## ADDENDUM # 002

**DATE: 4/30/2026**

Santa Fe Magistrate Courthouse  
NCA Job Number: A22.07

**New Mexico Administrative Office of the Courts  
ITB-2026-AOC-005**

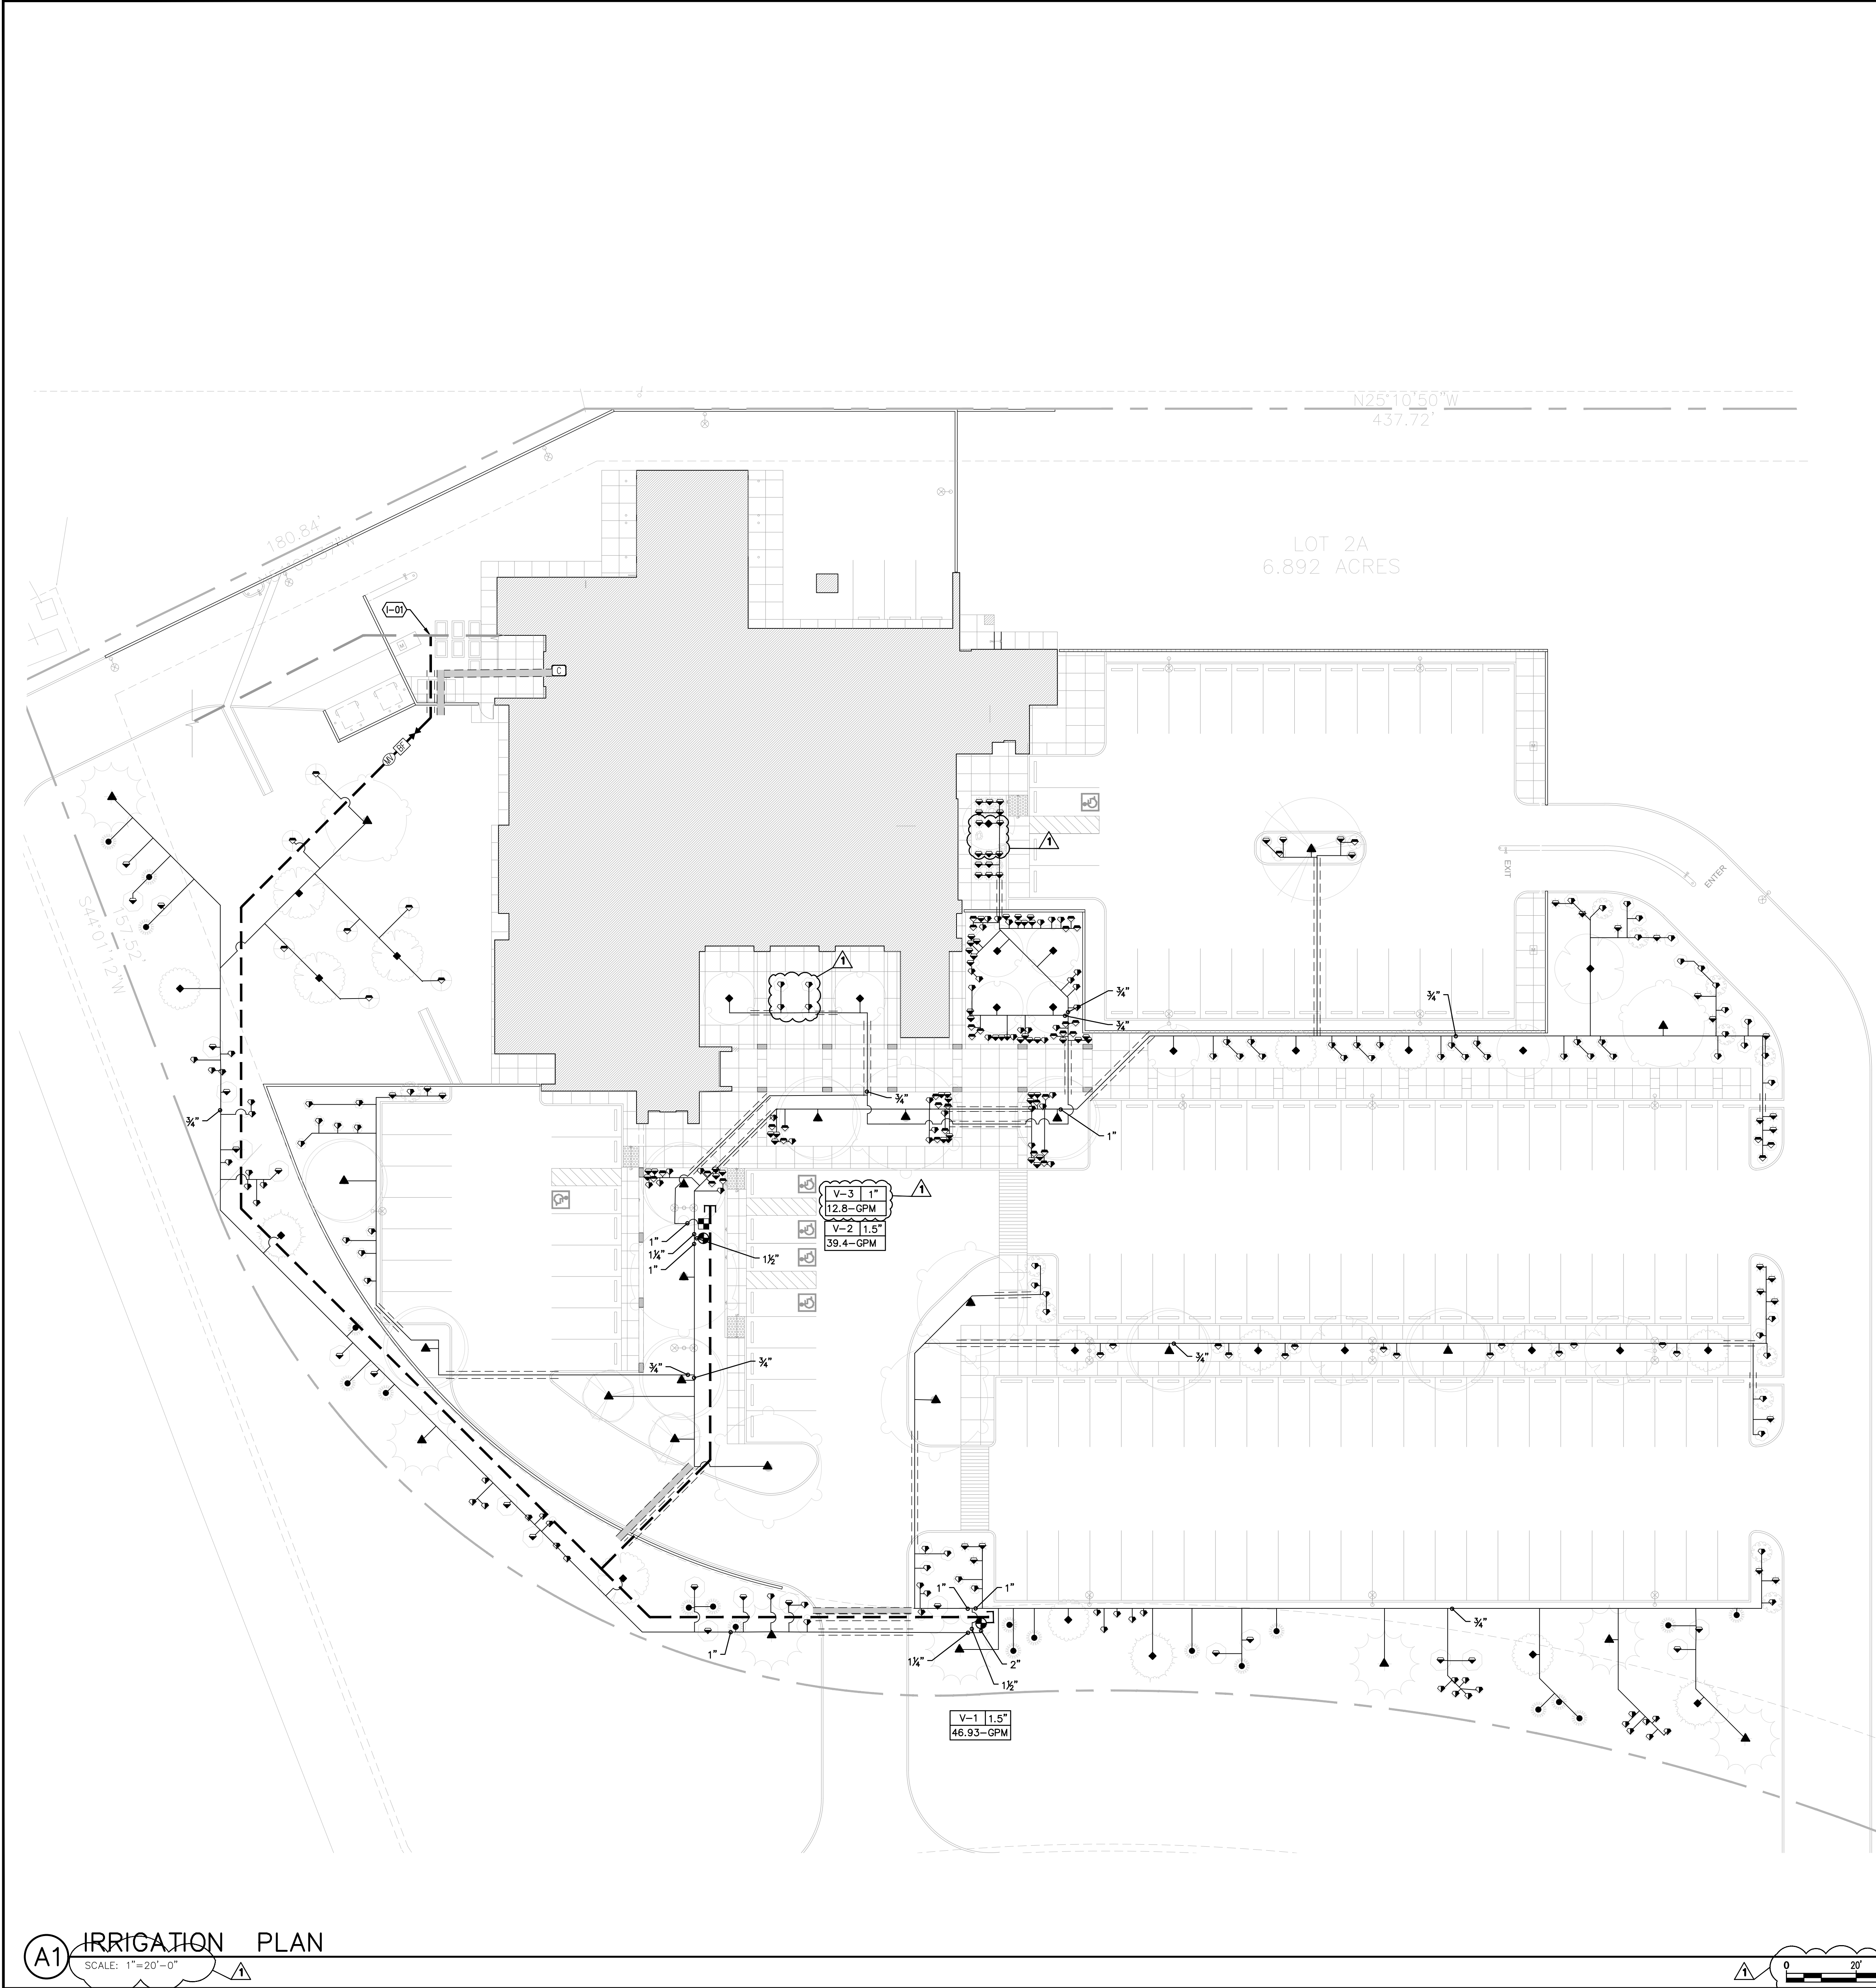
14. C-100, the Overall Grading and Drainage Plan, shows two retaining ponds. The water harvest area called out with keyed note 9 is addressed with planting and revegetative seeding, however the pond called out by keyed notes 10 does not show any treatment in plan view. Both ponds make reference to the detail Shown on Page D-501, D-1, Typical Water Harvest Area Section, should this detail apply to both ponds? Should the pond with Keyed Note 9 have riprap in addition to the seeding / planting as shown on the detail? Will the pond with Keyed Note 10 fall in the scope of the landscape contract?

**RESPONSE: THE POND WITH KEYED NOTE 9 SHALL INCLUDE THE SEEDING AND PLANTING AS SHOWN ON LP101 IN ADDITION TO THE RIPRAP SHOWN ON C-100 AND DETAIL D1/D-501. THE POND WITH KEYED NOTE 10 WILL NOT INCLUDE SEEDING OR PLANTING AND CONSTRUCTED PER DIRECTION ON CIVIL DRAWINGS.**

**SHEET NO.:** LI101

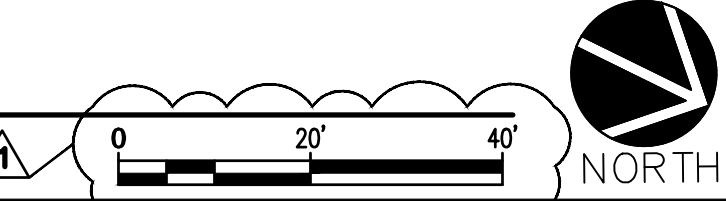
12. C-100, the overall grading and drainage plans shows a storm inlet in conflict with a Canada Red Chokecherry Tree, please let us know if we should include this tree and its irrigation in our final pricing.

**RESPONSE: PLANT SPECIES, PLANT LAYOUT, AND IRRIGATION HAVE BEEN REVISED AROUND STORM INLETS – SEE REVISED LI101 AND LP101 SHEETS FOR REVISIONS.**

**LP101**

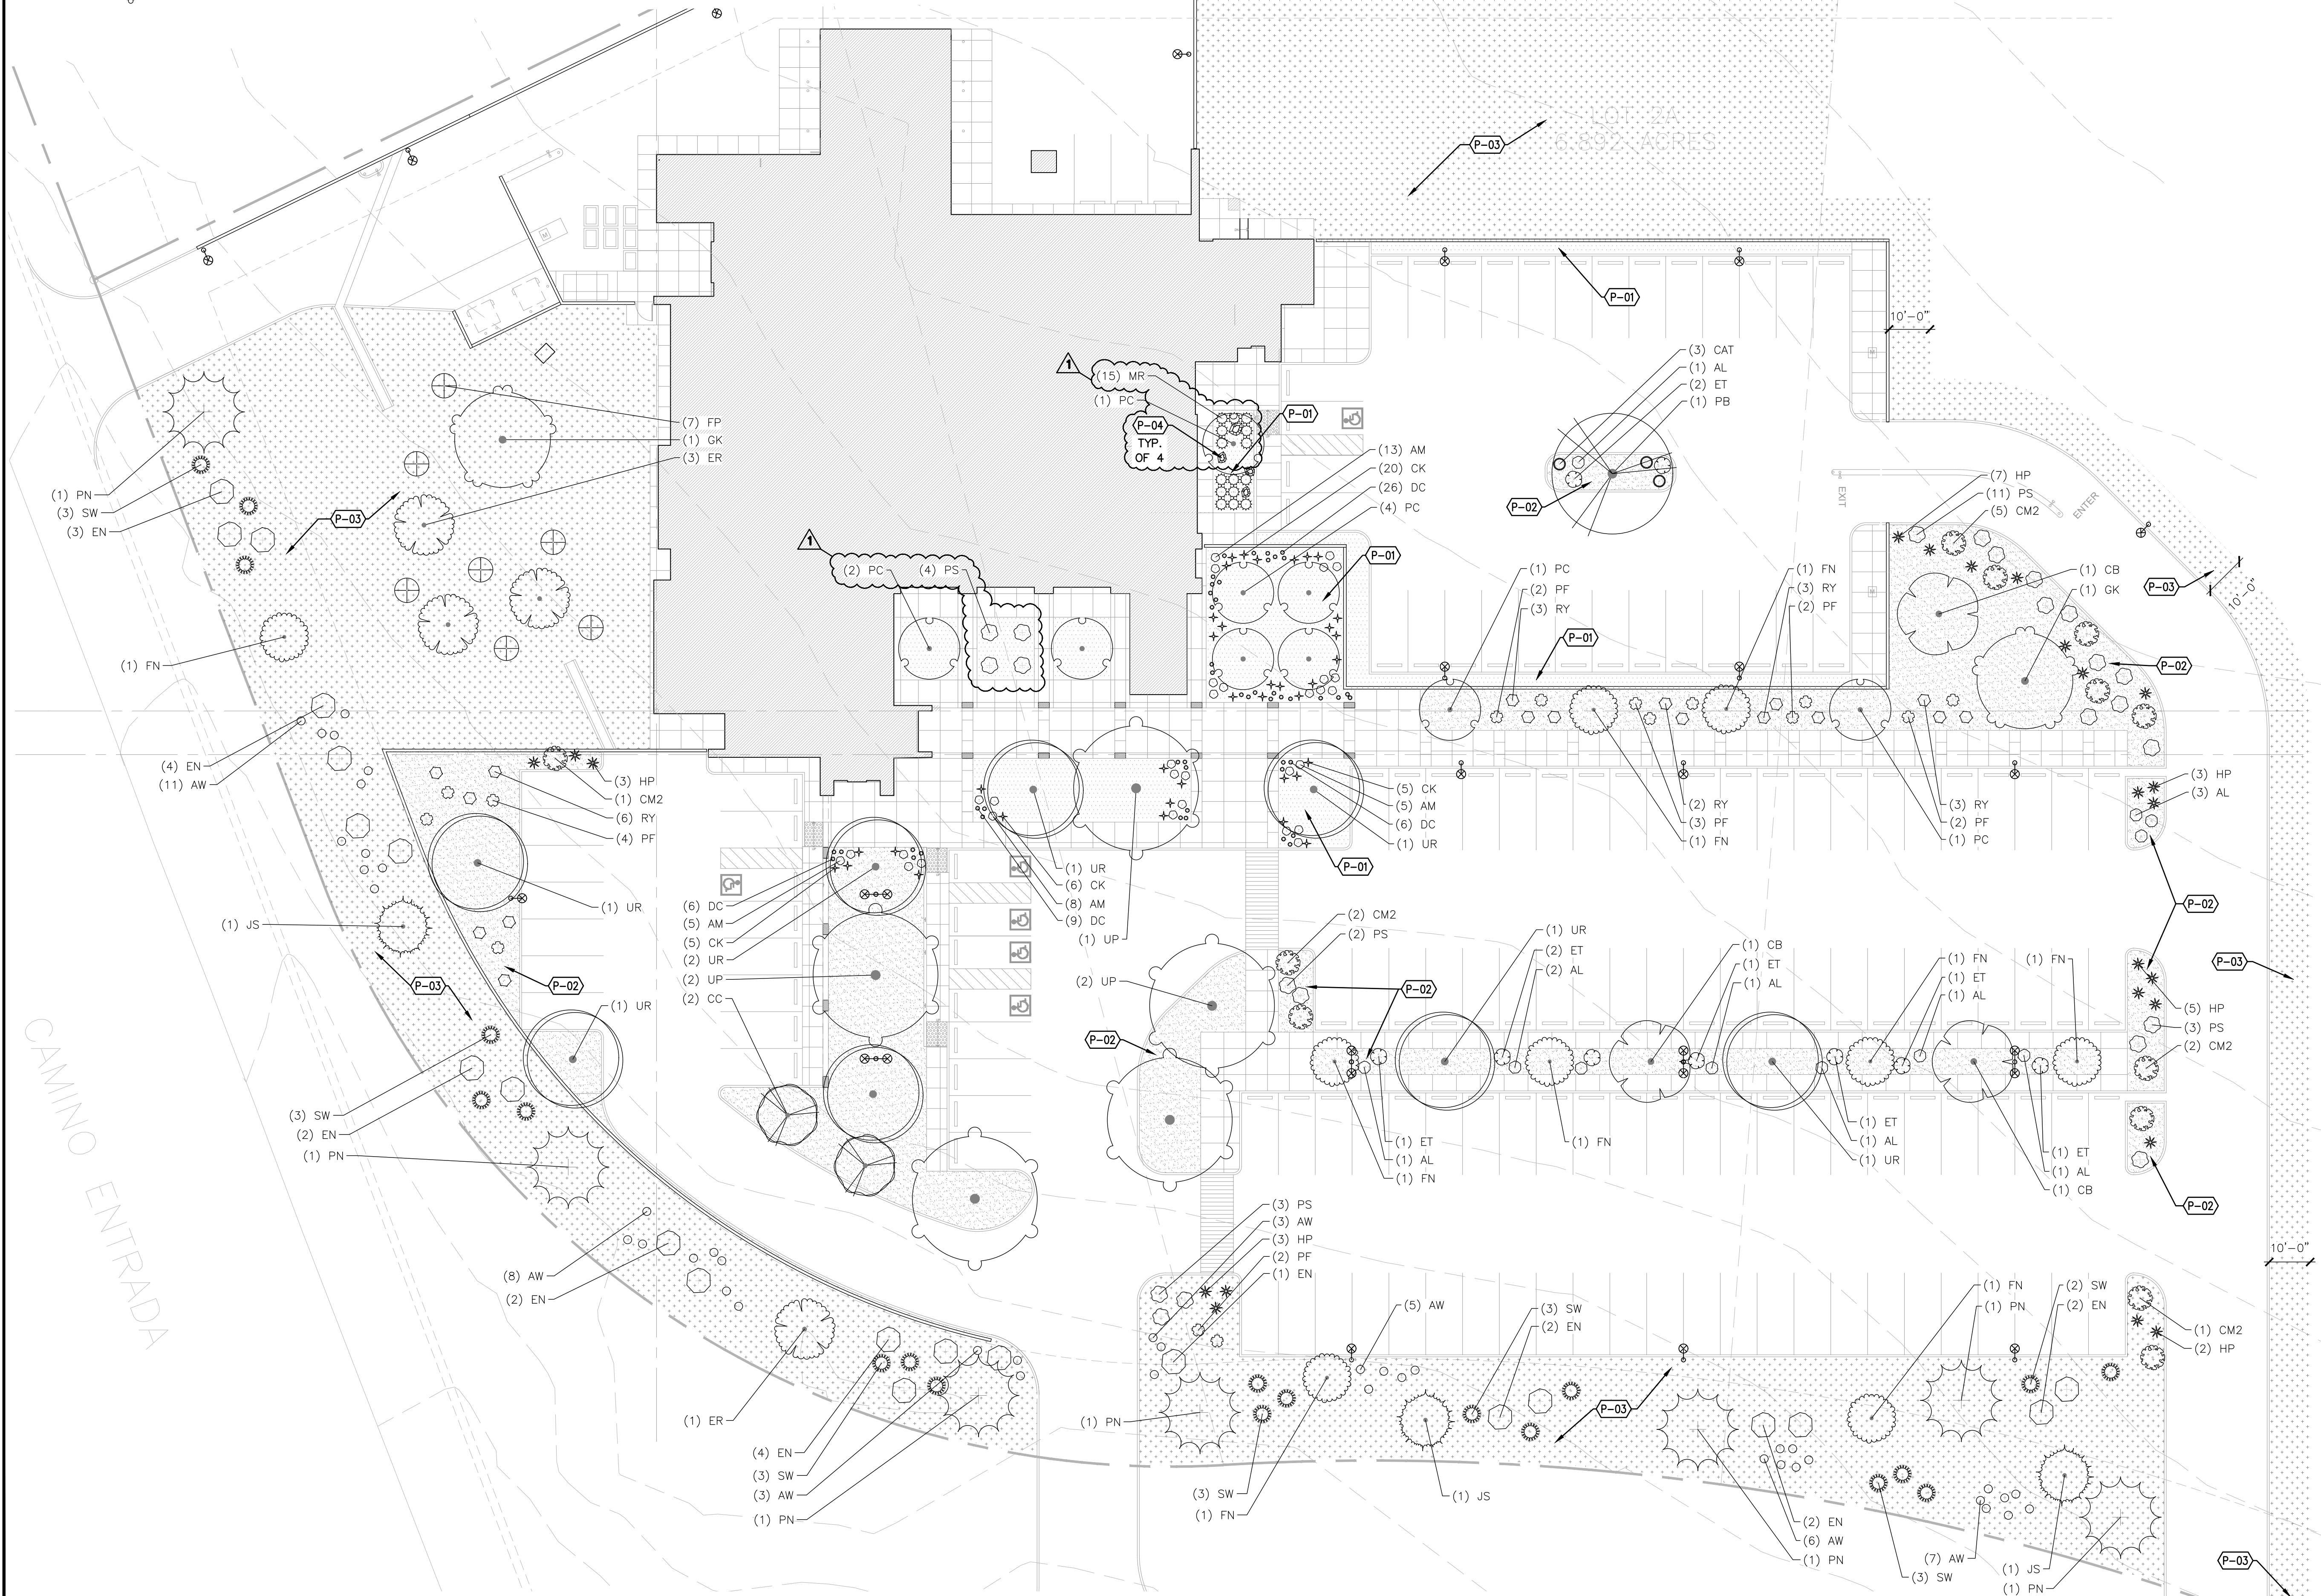
11. 4 boulders are shown in planters on LP101 but there are not specifications or details for the boulders called out on the plans – please clarify what boulders you would like to use?

**RESPONSE: ADDED KEYED NOTE P-04 “FURNISH AND INSTALL ACCENT BOULDER PER DETAIL B1/LP501,” TO LP101 AND ACCENT BOULDER DETAIL B1/LP501.**
